Errata to MPC8548E PowerQUICC III Integrated Host Processor Family Reference Manual, Rev. 2

This document describes corrections to the *MPC8548E PowerQUICC III Integrated Host Processor Family Reference Manual*, Revision 2. For convenience, the section number and page number of the errata item in the reference manual are provided. Items in bold are new since the last revision of this document.

Figure 5-3. MU Pipeline, Showing Divide Bypass

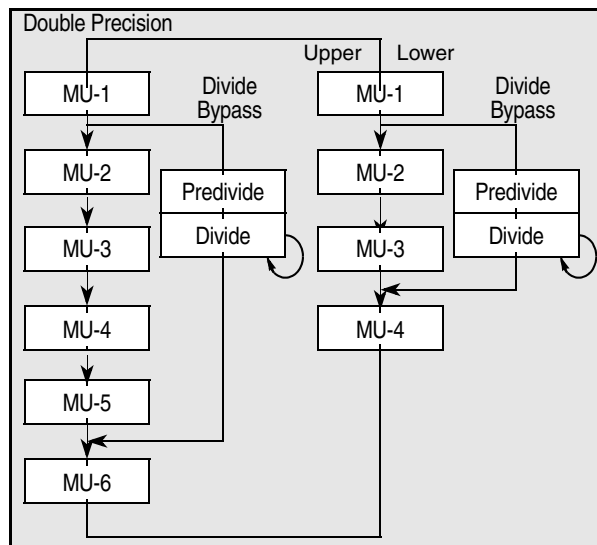
Modify Figure 5-3, “Four-Stage MU Pipeline, Showing Divide Bypass,” and change title to “MU Pipeline, Showing Divide Bypass,” as follows:

In addition, add the following text to the first bullet under the MU features:
 “Six-cycle latency for double-precision multiplication.”

Figure 14-10. TBIPA Register Definition

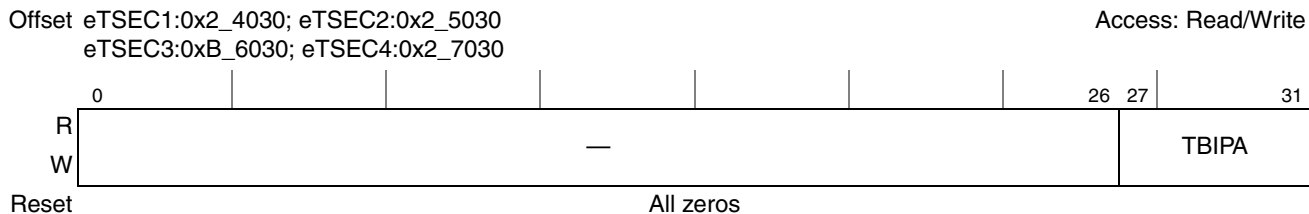
14.5.3.1.9, 14-36 Replace Figure 14-10, “TBIPA Register Definition,” with the following:

Figure 14-110. RQPRM Register Definition

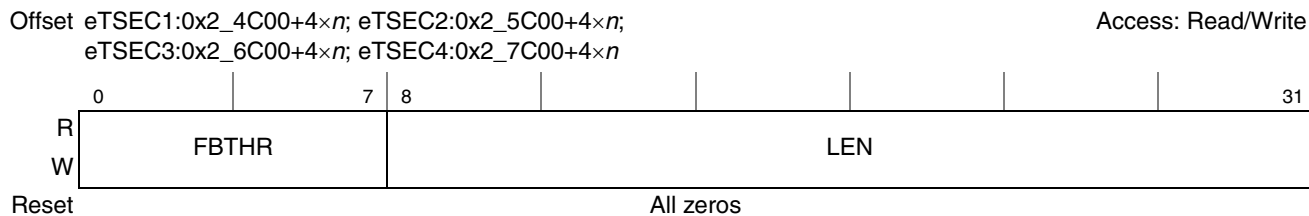
The RQPRM n registers specify the minimum number of BDs required to prevent flow control being asserted and the total number of Rx BDs in their respective ring. Whenever the free BD count calculated by the eTSEC for any active ring drops below the value of RQPRM n [FBTHR] for that ring, link level flow control will be asserted. Software must not write to RQPRM n while the eTSEC is actively receiving frames. However, software may modify these registers while the receiver is disabled or has halted operation due to the completion of a GRACEFUL RECEIVE STOP command. [Figure 14-110](#) describes the definition for the RQPRM n register.

Figure 14-111. RFBPTR0–RFBPTR7 Register Definition

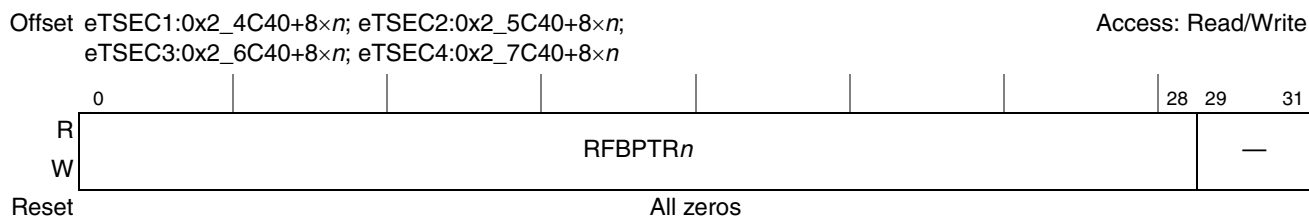
The RFBPTR_n registers specify the location of the last free buffer descriptor in their respective ring. These registers live in the same 32b address space – and must share the same 4 most significant bits – as RBPTR_n. That is, RFBPTR_n and its associated RBPTR_n must remain in the same 256MB page. Like RBPTR_n, whenever RBASE_n is updated, RFBPTR_n will be initialized to the value of RBASE_n. This indicates that the ring is completely empty. As buffers are freed and their respective BDs are returned (by setting the EMPTY bit) to the ring, software is expected to update this register. The eTSEC will then perform modulo arithmetic involving RBASE_n, RBPTR_n and RFBPTR_n to determine the number of free BDs remaining in the ring. If, at any stage, the value written to RFBPTR_n matches that of the respective RBPTR_n the eTSEC free BD calculation will assume that the ring is now completely empty. For more information on the recommended use of these registers, see [Section 14.6.6.2, “Software Use of Hardware-Initiated Back Pressure.”](#) Figure 14-111 describes the definition for the RFBPTR_n register.

Figure 14-109. ATTRELI Register Definition

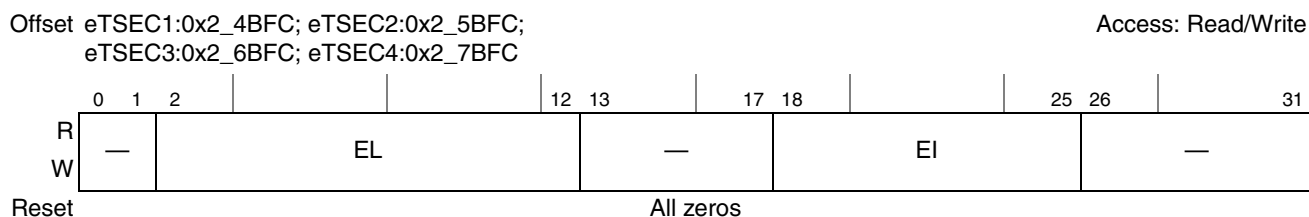
14.5.3.10.2, 14-113 In Figure 14-109, “ATTRELI Register Definition,” and Table 14-112, “ATTRELI Field Descriptions,” change size of AEI field. The updated register definition and field description appear as follows:

14.5.3.10.2, 14-113 In Table 14-112, “ATTRELI Field Descriptions,” replace EI (bits 18–25) field description with the following: “Extracted index. Points to the first byte, as a multiple of 64 bytes, within the receive frame as sent to memory from which to begin extracting data.”

Figure 17-48. Physical Configuration Register (PCR)

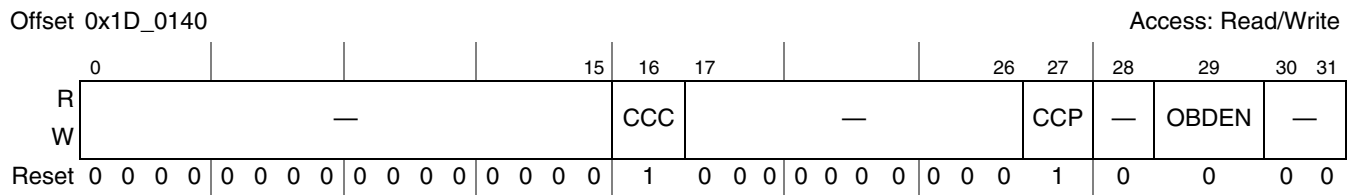
In Figure 17-48, “Physical Configuration Register (PCR),” CCP should be represented as a read/write bitfield. The updated definition appears as follows:

Figure 18-68. PCI Express Prefetchable Memory Base Register

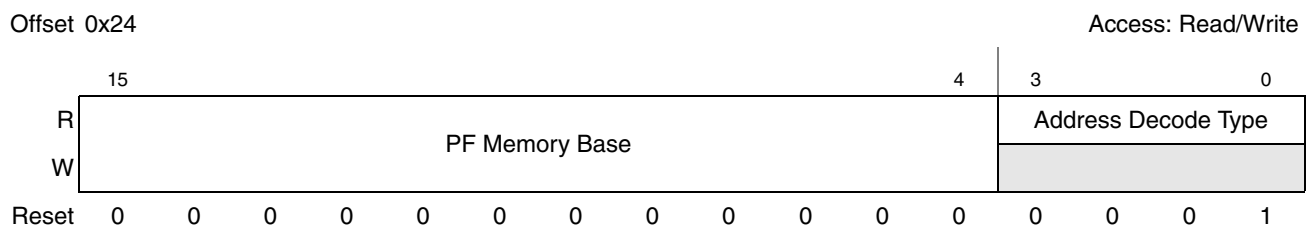
18.3.8.3.11, 18-62 Replace Figure 18-68, “PCI Express Prefetchable Memory Base Register,” with the following:

Figure 18-69. PCI Express Prefetchable Memory Limit Register

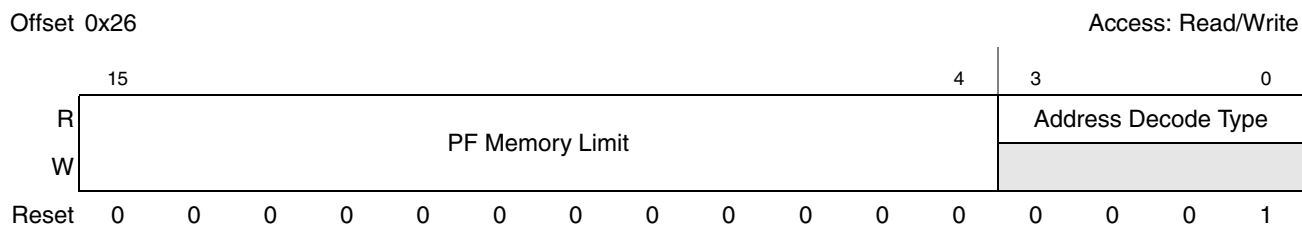
18.3.8.3.12, 18-63 Replace Figure 18-69, “PCI Express Prefetchable Memory Limit Register,” with the following:

Figure 18-106. PCI Express Correctable Error Status Register

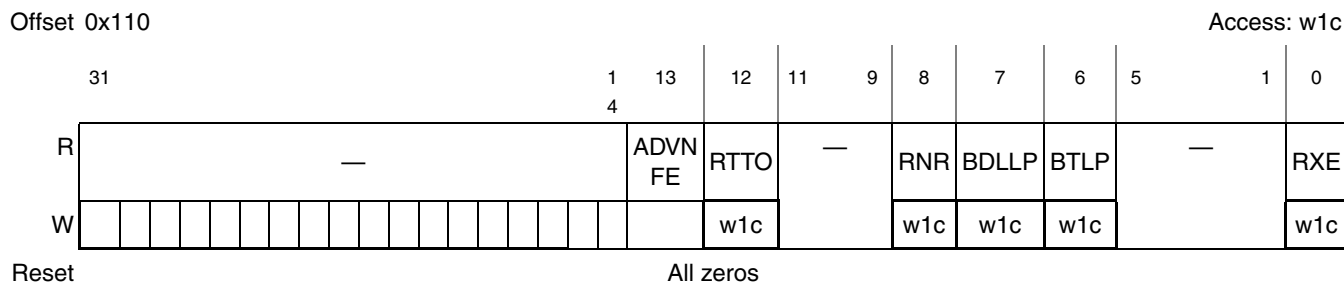
“Note that a completion timeout error is a fatal error. If a completion timeout error is detected, the system has become unstable. Hot reset is recommended to restore stability of the system.”
- 18.3.10.5, 18-84** Replace Section 18.3.10.5, “PCI Express Correctable Error Status Register—0x110,” with the following:

Figure 18-107. PCI Express Correctable Error Mask Register

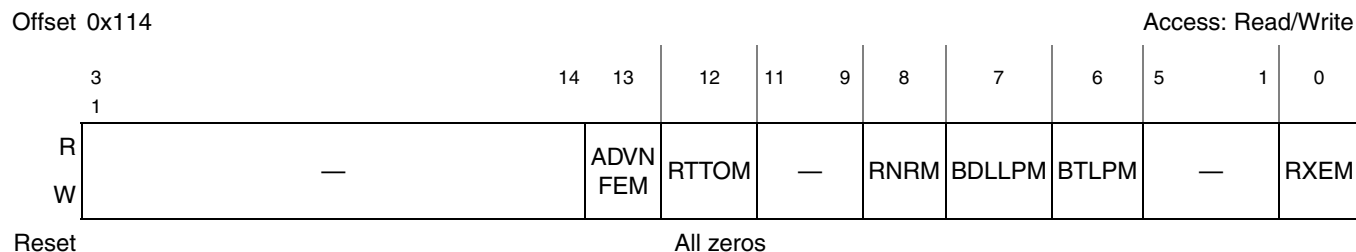
18.3.10.5, 18-85 Replace Section 18.3.10.5, “PCI Express Correctable Error Mask Register—0x114,” with the following:

Figure 20-1. POR PLL Status Register (PORPLLSR)

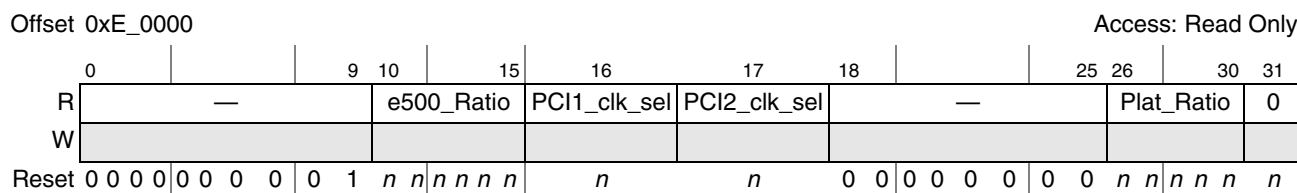
20.4.1.1, 20-5 In Figure 20-1, “PORPLL Status Register (PORPLLSR),” change reset value for bits 8–9 to from “00” to “01,” as follows:

Figure 20-25. SerDes Control Register 1 (SRDSCR1)

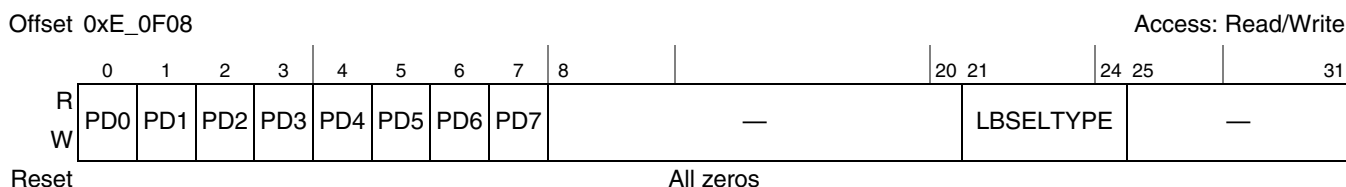
20.4.1.25, 20-27 Add field SRDSCR1[LBSSELTTYPE] in Figure 20-25, “SerDes Control Register 1 (SRDSCR1),” and its corresponding field description in Table 20-28, “SRDSCR1 Field Descriptions.” The register figure and field description table changes should appear as follows:
